Date: ~~May 4~~ June 17, 2004
 To: T10 Technical Committee
 From: Alvin Cox (alvin.cox@seagate.com), Mike Jenkins (jenkins@lsil.com)
 Subject: SAS TCTF update

5.3.11 Transmitter characteristics

Figure 53 — ISI loss example at 3,0 Gbps

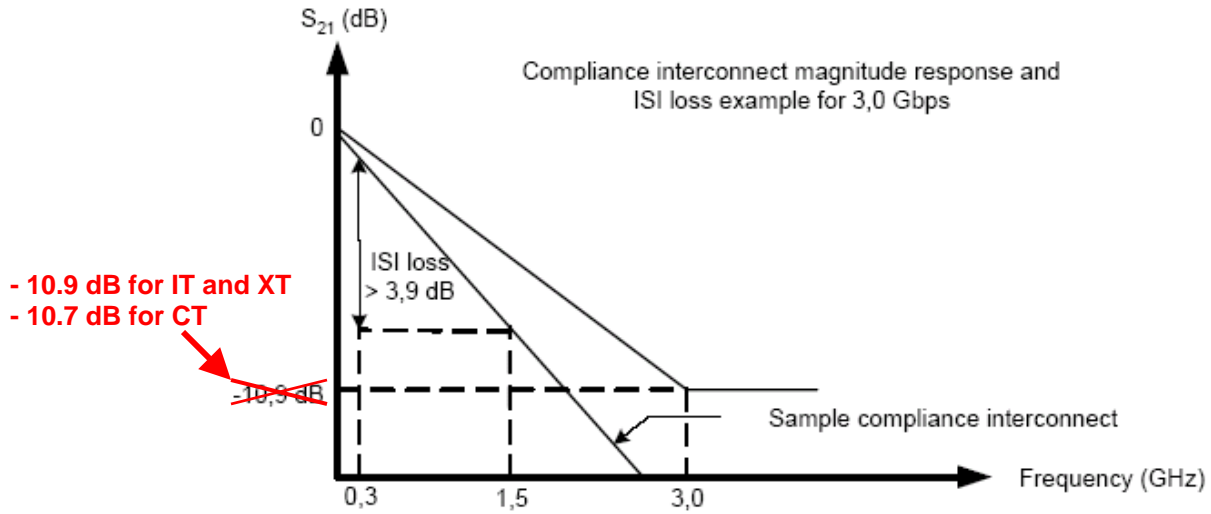
Revise the text and figures as indicated below:

The TCTF is used to specify the requirements on transmitters that may or may not incorporate pre-emphasis or other forms of compensation. A compliance interconnect is any physical interconnect with loss equal to or greater than that of the TCTF at the above frequencies that also meets the ISI loss requirements shown in figure 53 and figure 54. Transmitters compliant to the CT requirements are also deemed compliant to the IT and XT requirements.

Figure 54 — ISI loss example at 1,5 Gbps

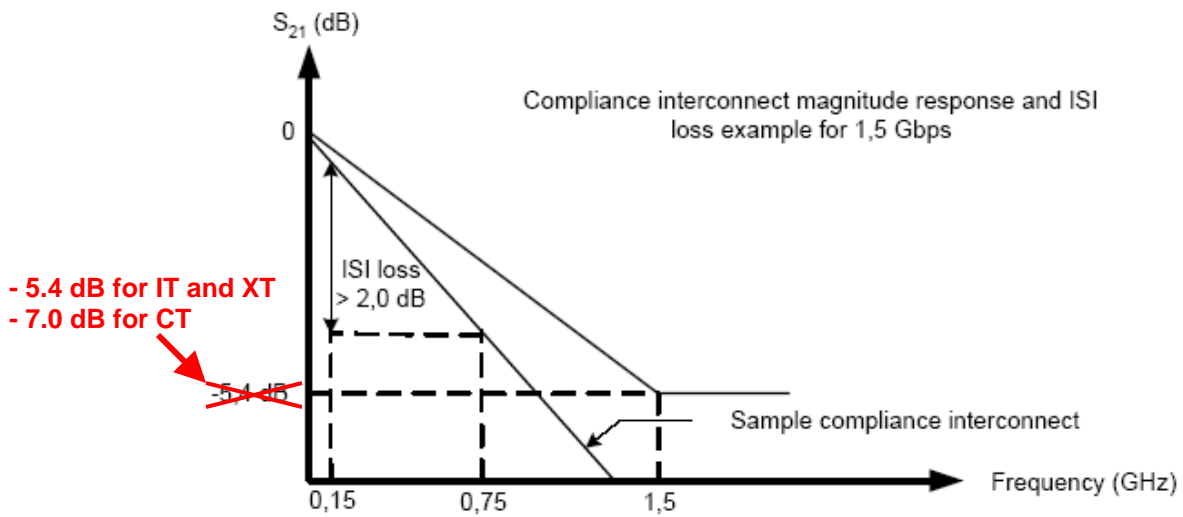
Figure 54 shows an ISI loss example at 1,5 Gbps.
